Title		
Power Supply		
Size	Document Number	Rev
A	<Doc>	<RevCode>
Date:	Sunday, May 29, 2022	Sheet 1 of 1

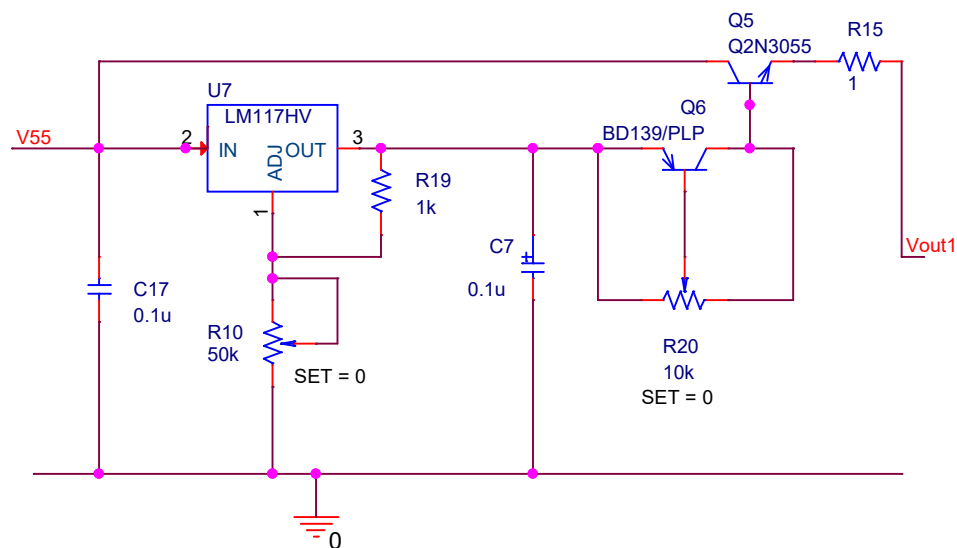
Diode D1 & D2 should be 50V, 15A
Here, both of them are 50V, 3A
They should be replaced.
